SUNDRY NOTICES AND REPORTS ON WELLS

| 2. NAME OF OPERATOR ARCO OIL & GAS COMPANY, A Division of Atlantic Richfield. | | 5. IF INDIAN, ALLOTTEE OR TRIBE NAME Navajo |

**HORSESHOE GALLUP UNIT PRODUCING WELLS
PLUGGING AND ABANDONMENT PROCEDURE**

CONDITIONS OF APPROVAL

CURRENT WELLBORE CONFIGURATIONSPUDED: 02/02/59UNIT: M SEC: 2 TWSP: 30N RG: 16WCOMPLETED: 03/07/59LOCATION: 330' FSL & 330' FWLGL: 5558' KB: 5566'TUBING:DATE LAST PULLED: 08/03/65

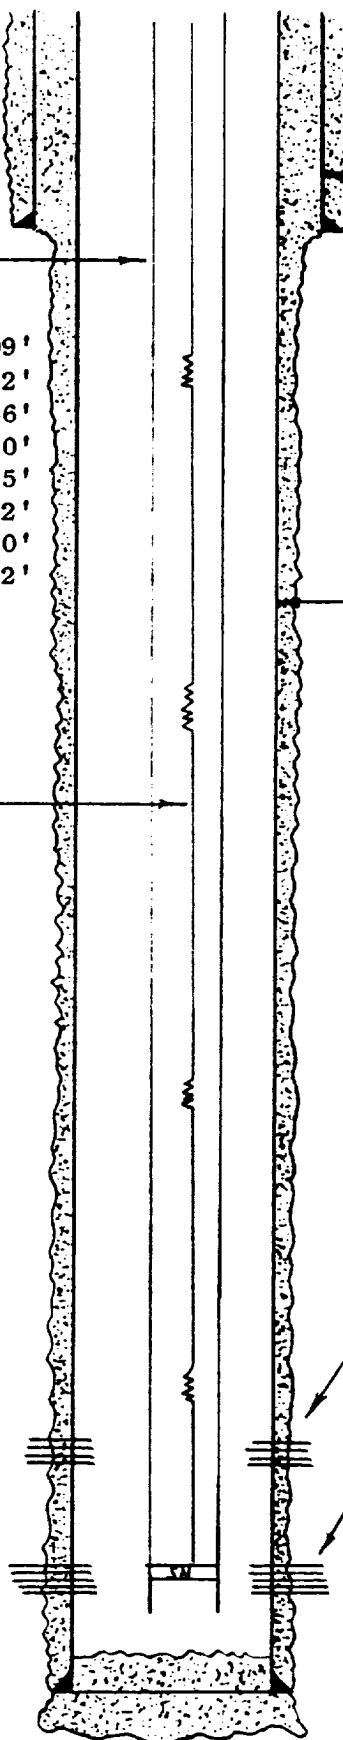
1. Plugging operations authorized are subject to the attached "General Requirements for Permanent Abandonment of Wells on Federal Leases."
2. Bill Blackwell with the Farmington Office is to be notified at least 24 hours before the plugging operations commence (505) 327-5344.
3. Blowout prevention equipment is required.
4. The following modifications to your plugging program are to be made (when applicable):
